SAFETY EVALUATIONFORVALIDATION OF BECHTEL COMPUTER CODE SASSI FOR APPLICATION TO  
WATTS BAR NUCLEAR PLANT SOIL-STRUCTURE INTERACTION ANALYSISTENNESSEE VALLEY AUTHORITY (TVA)WATTS BAR NUCLEAR PLANT (WBN) UNITS 1 AND 2DOCKET NOS. 50-390 AND 50-391

## 2.0 PURPOSE AND SCOPE

Fig. 5 Comparison of SASSI Solutions for Surface and Embedded Foundation Conditions - Diesel Generator Building, EW Direction, 3% Damping ARS at Top of Building (Ref. 5)

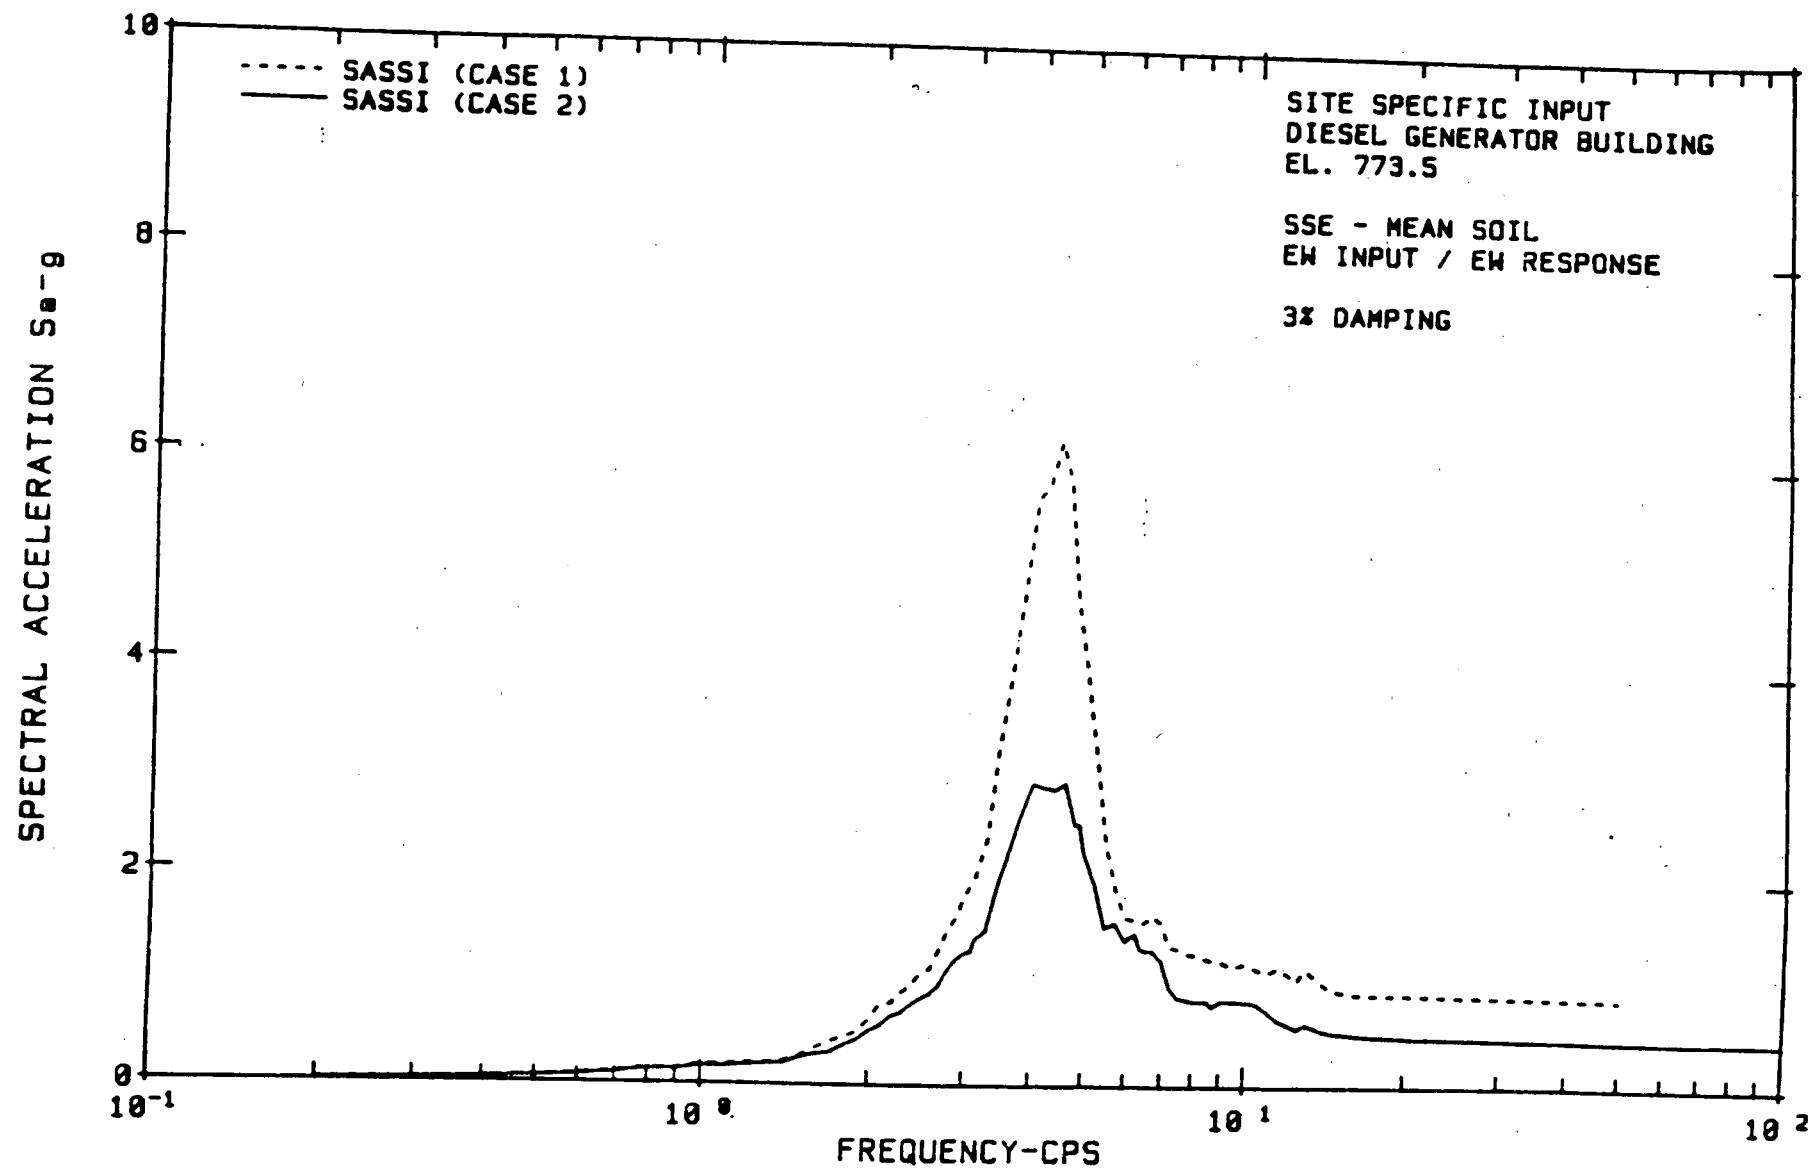
- (4) Comparing the solutions for SASSI Cases 1 and 2 or CLASSIF Cases 1 and 4 initially suggested that structural embedment has the effect of substantially reducing the structural response at WBN. This was especially the case with the DGB, as illustrated in Fig. 5. The staff and consultant, however, did not expect such a substantial reduction in view of the fact both structures are only shallowly embedded. Bechtel Validation Test Problem No. 9, which qualitatively benchmarks the SASSI solution for a shallowly embedded building against a CLASSIF solution for the same building founded on the ground surface, also indicates that the shallow embedment need not substantially reduce the structural response. In view of the incompatibility between the input motion and the hypothetic ground surface assumed in the Case 1 SSI model, as pointed out previously in finding (2), the staff envisioned that re-running the Case 1 analysis with the same SSI model and a compatible input motion will provide a better understanding of the significance of the structural embedment. The compatible input motion in this event would be the free-field motion computed at the hypothetic surface. In lieu of such reanalysis with either the SASSI or CLASSIF code, however, the staff believed the same purpose would be essentially fulfilled by simply comparing the free-field motions at Locations A, B, and C as shown in Fig. 4 in the case of the DGB, where the motion at Location C would be the compatible input motion mentioned previously. Bechtel therefore performed additional soil column analyses with the SHAKE code to compute the EW component of the motions at Locations B and C for the DGB. In addition, Bechtel extracted the EW translational component of the free-field scattered motion at the foundation, i.e., Location D as shown in Fig. 4, from the SASSI Case 2 analysis. Fig. 9 provides a spectrum comparison for the motions at the locations A, B, C and D (Ref. 5, Appendix A). Around the system frequency of the SSI model for the DGB, which was estimated to be about 4.5 Hz, the spectrum acceleration of motion C is much lower than that of motion A. It suggests that should Case 1 be re-analyzed with motion C as the input the response of the DGB would not be as high as that with motion A as the input. That is, the reduction in structural response due to the shallow embedment of the basemat would indeed be less substantial than as initially suggested. The initial concern of the staff and consultant was therefore resolved.

Fig. 7 Comparison of SASSI and CLASSI Solutions for DGB ARS for the Hypothetic Surface-Founded Condition, EW-Direction at the Top of Building (Ref. 5)

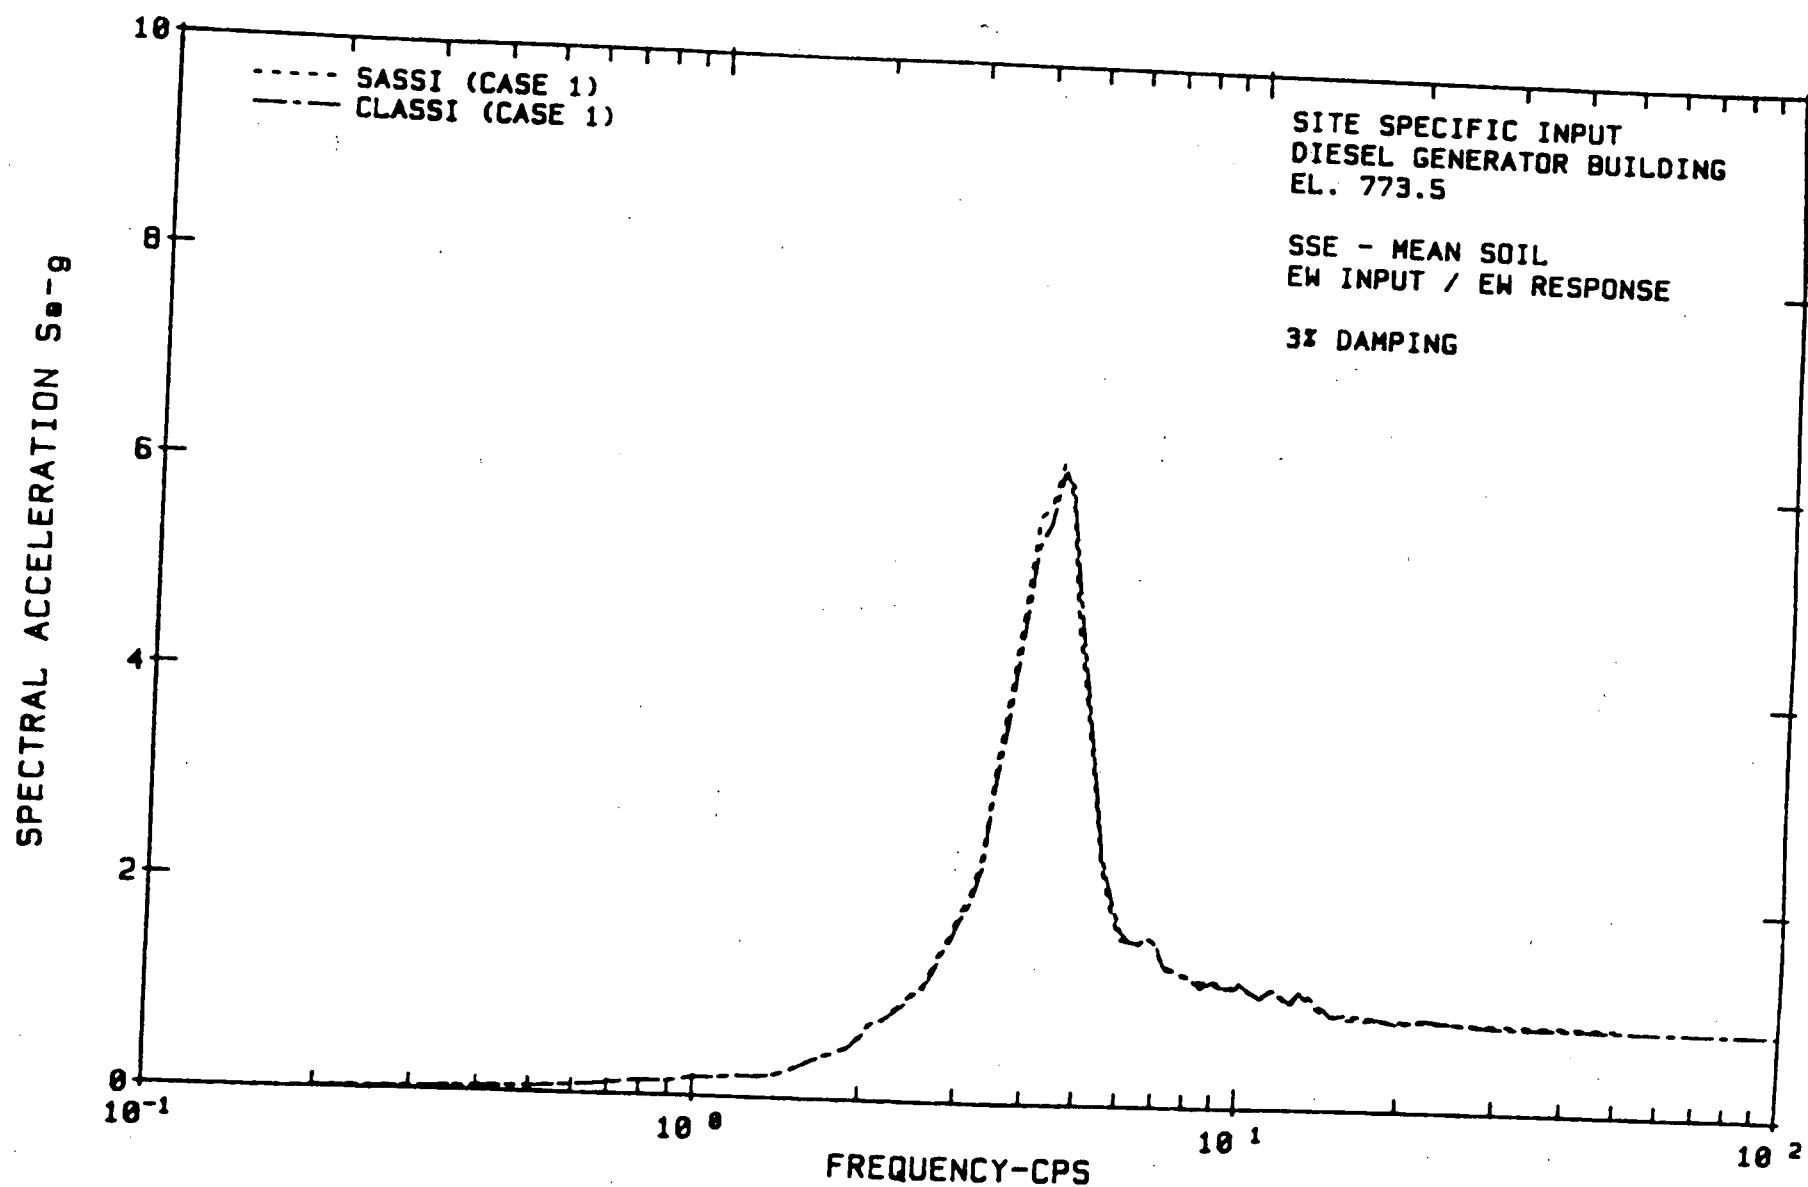
- (2) For the hypothetic surface-founded condition, the SASSI and CLASSIF solutions are comparable to each other. For example, Fig. 7 shows the ARS comparison at the center of the DGB roof. In the absence of structural embedment, such close comparison was anticipated according to the theories of the two codes. Thus the CLASSIF solution provided a plant-specific validation for the SASSI code in the case of surface-founded structures. The staff and consultant noted the incompatibility between the ground surface (e.g., Location A in Fig. 4), on which generation of the free-field input motion was based, and the hypothetic surface (e.g., Location C in Fig. 4) for the SSI model. However, because the incompatibility is common to both the SASSI and CLASSIF solutions the review finding regarding the SASSI code in the case of surface-founded structures remains valid.

Fig. 8 Comparison of SASSI and CLASSI Solutions for DGB ARS for the Embedded Condition, EW-Direction at the Top of Building (Ref. 5)

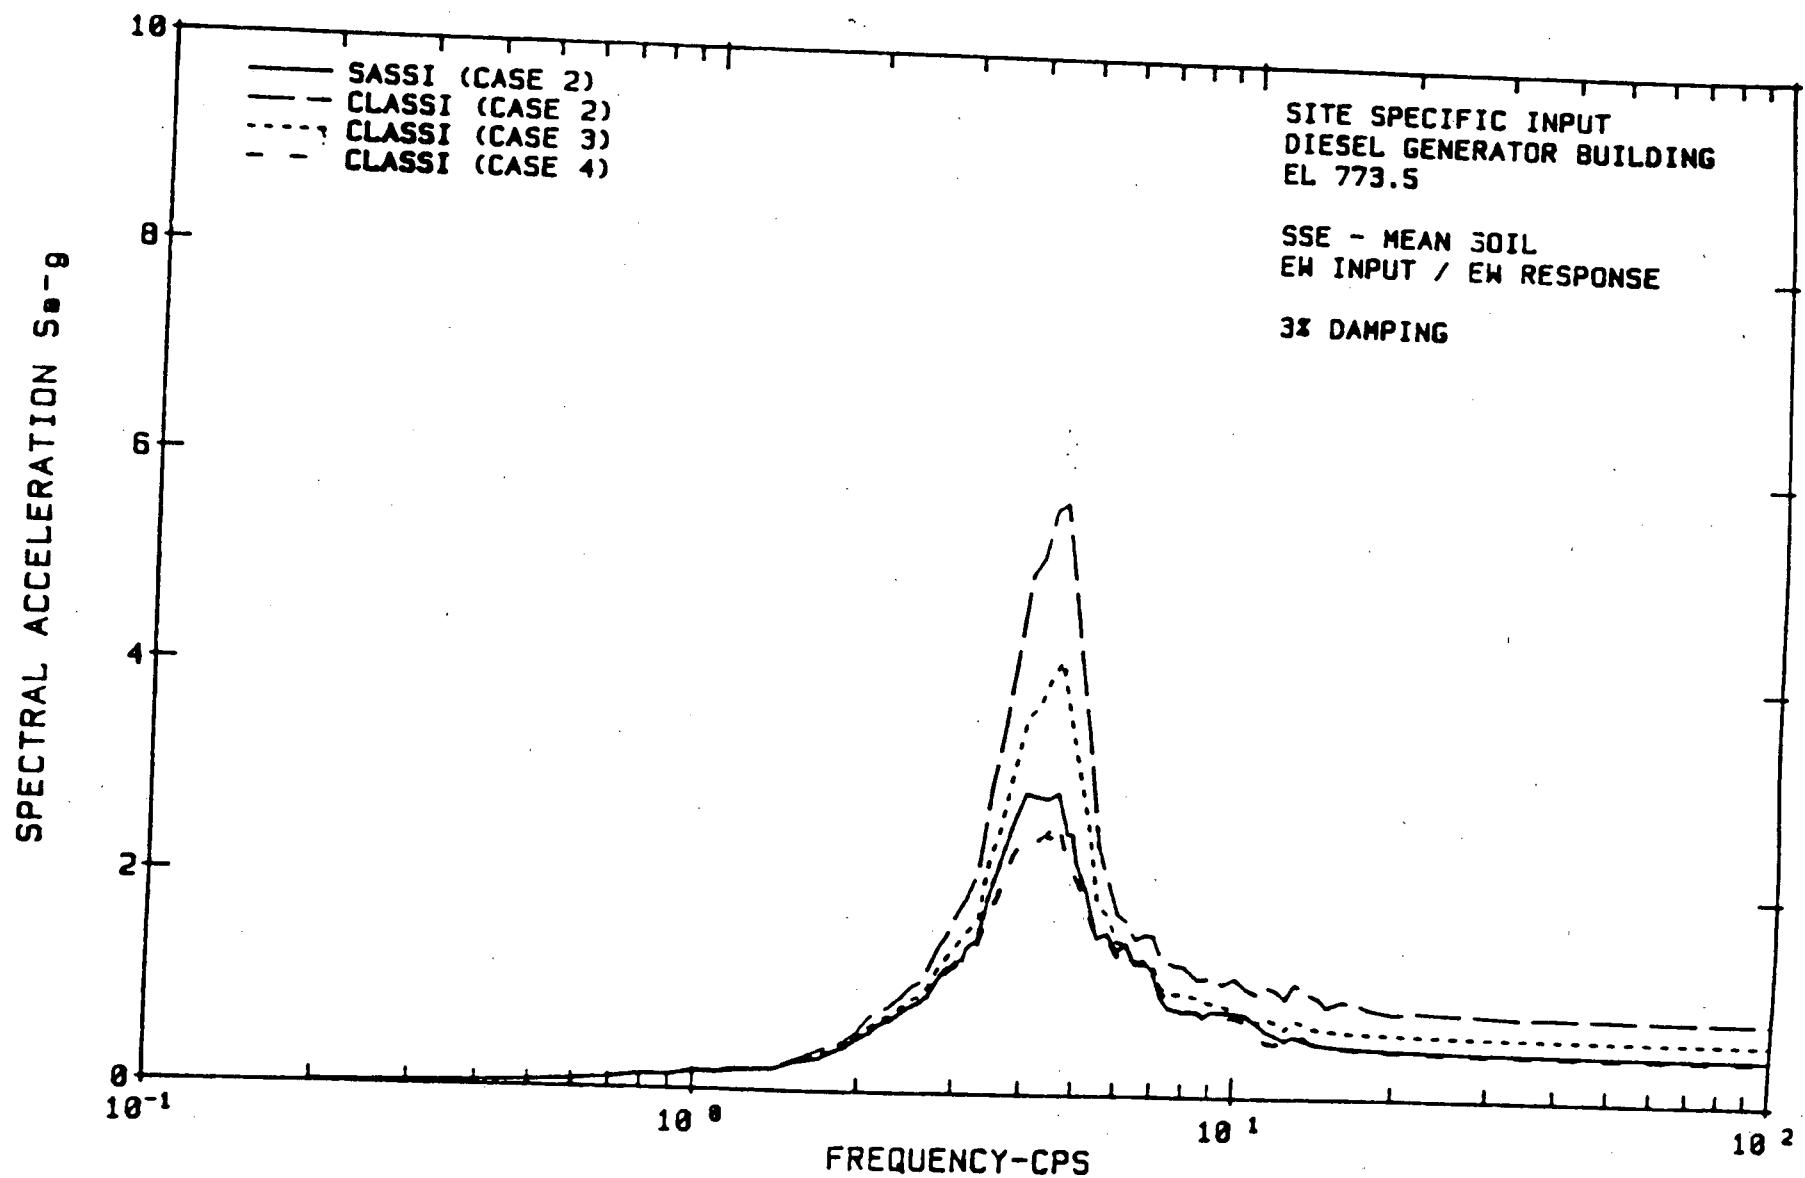
- (3) For the as-built embedded condition, the solution for SASSI analysis Case 2 compares well to that for CLASSIF analysis Case 4. This was anticipated because CLASSIF Case 4 was run using both the impedances and wave scattering functions that were generated from SASSI Case 2. For example, Fig. 8 shows the ARS comparison between the two solutions at the center of the DGB roof.

Thus the solution from CLASSIF Case 4 provided the SASSI code with a qualitative benchmarking in the case of embedded structures. In addition, the staff and consultant noted: (a) comparison between CLASSIF Cases 2 and 3 suggested that the empirically modified CLASSIF impedances are not a good approximation to the SASSI impedances at WBN, and (b) comparison between CLASSIF Cases 3 and 4 suggested the wave scattering due to structural embedment is important at WBN.

Fig. 9 Comparison of 5% Damping Spectra in EW Direction for Free-  
 Field Motion at Locations A, B, C and D Shown in Fig. 4 for DGB  
 (Ref. 5)

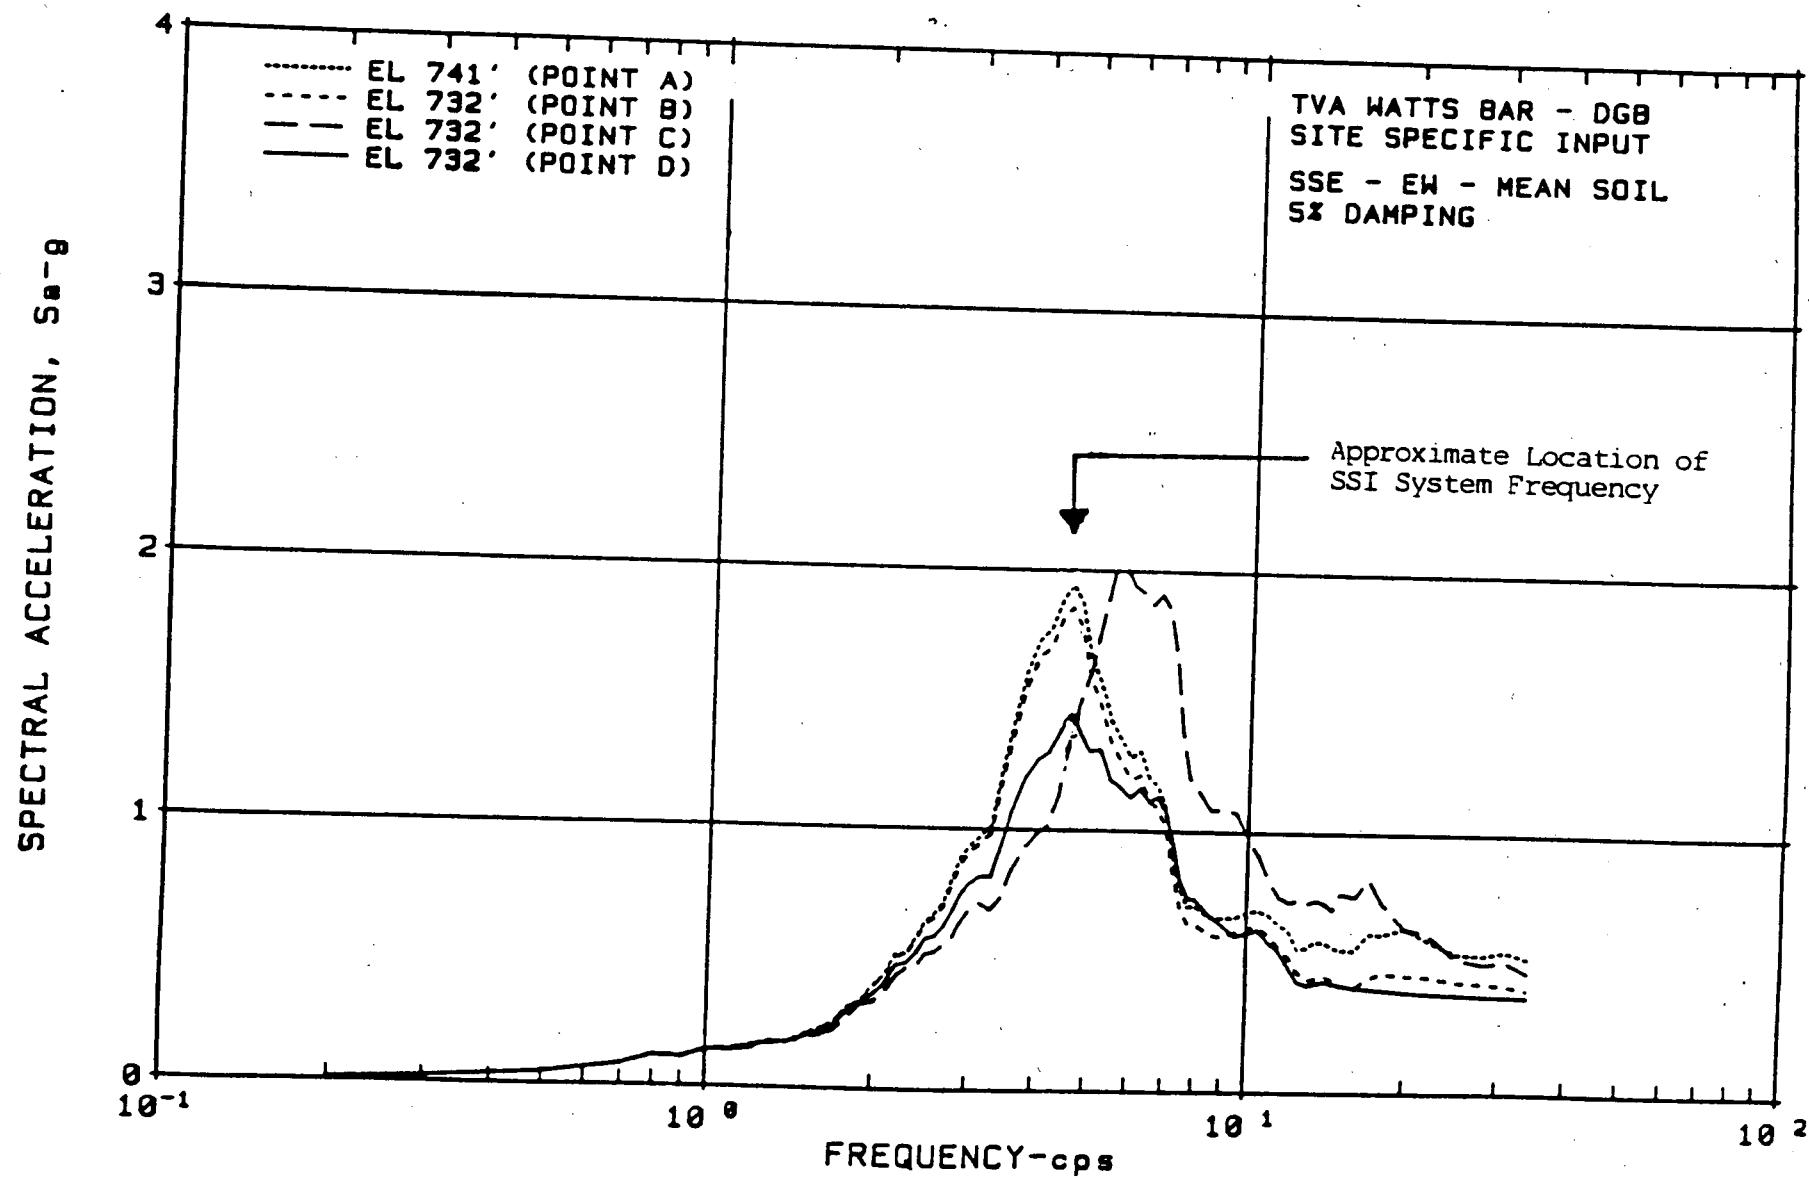
- (5) As discussed previously in finding (3), the staff and consultant noted the significance of wave scattering on the response of the DGB and RWST due to the structural embedment. The spectrum comparison for motions A, B and D as shown in Fig. 9 led to the same observation. As an additional evidence, Bechtel provided a summary of the results from some published studies on several strong-motion earthquakes (Ref. 7). The scaled model is located in Lotung, Taiwan, and is moderately embedded in a soft soil foundation. Fig. 10 illustrates the vertical cross section of the scaled containment model. Fig. 11 shows the variation of the recorded free-field motions from the surface to -47m in the ground during one of the earthquakes. The earthquake,
